LiDAR Quality Assessment Report

Materials Received: 9/7/2011	Project Type: GPSC
Project ID: ID_City-of-Rocks_2011	Project Description: Approximately 81 square miles of 1.0m NPS lidar.
Project Alias(es):	Year of Collection: 2011

City of Rocks National Park Lidar

Checkpoint Distribution Image?

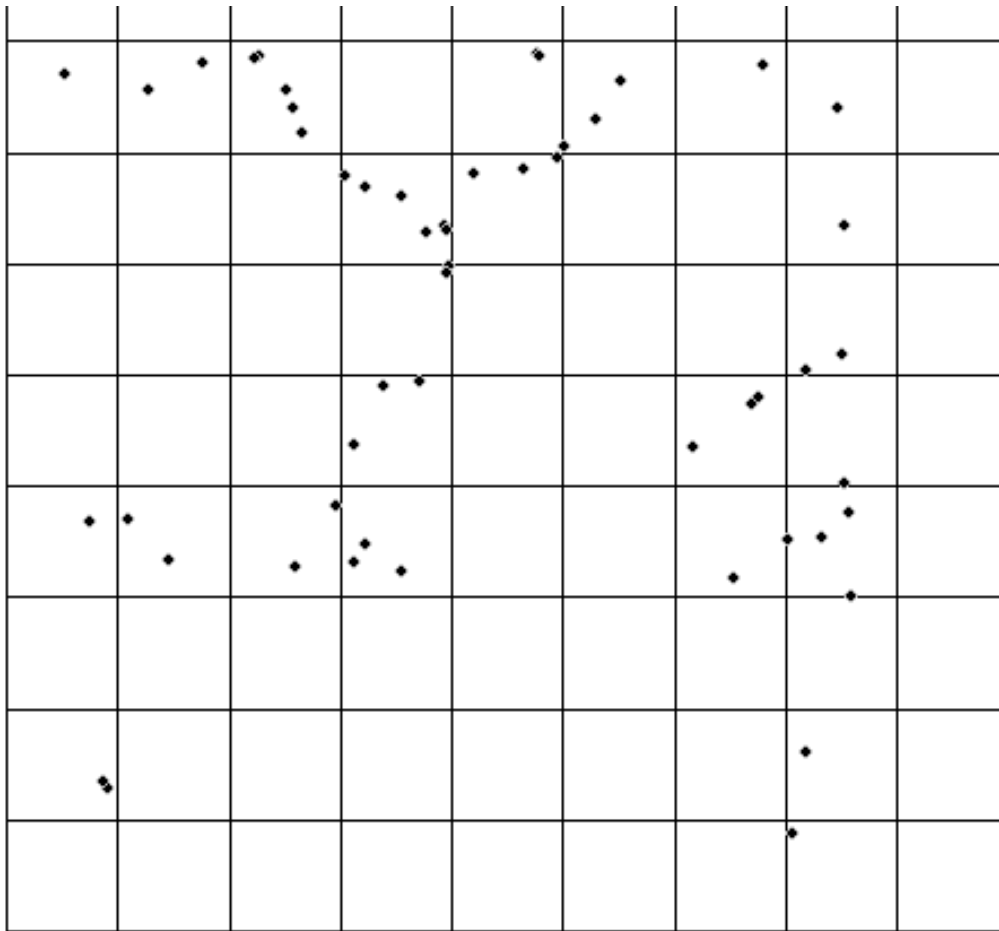
Task order required only 20 points in each of the three major land covers. Distribution as limited by park access and roads. Distribution as provided is acceptable.

From Pos: 768478.803, 4657775.372 To Pos: 768532.764, 4657773.574

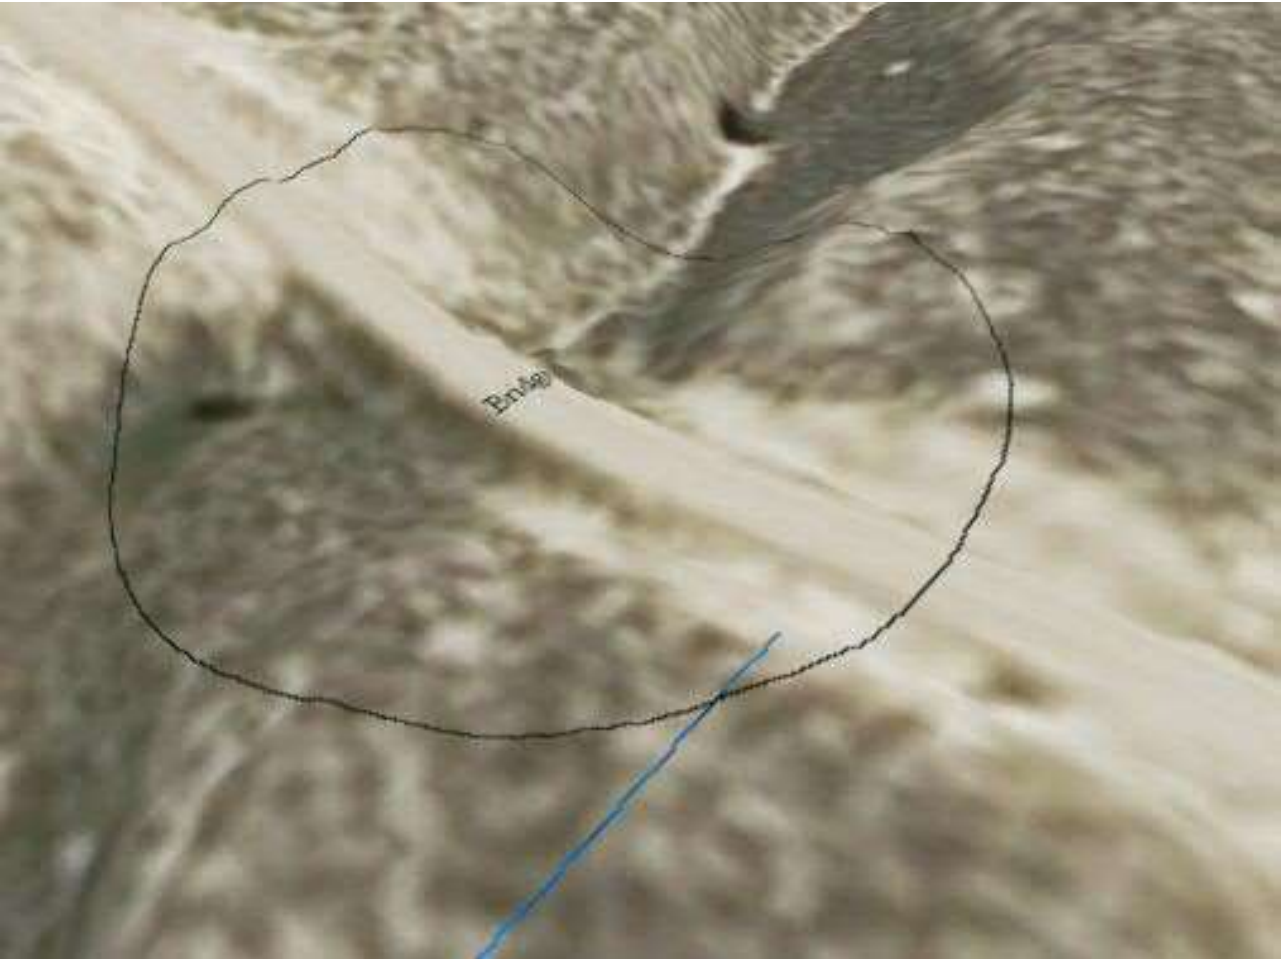
Strange Cross Hatch Patter in Data, does not appear to greatly affect elevation, but is noted.
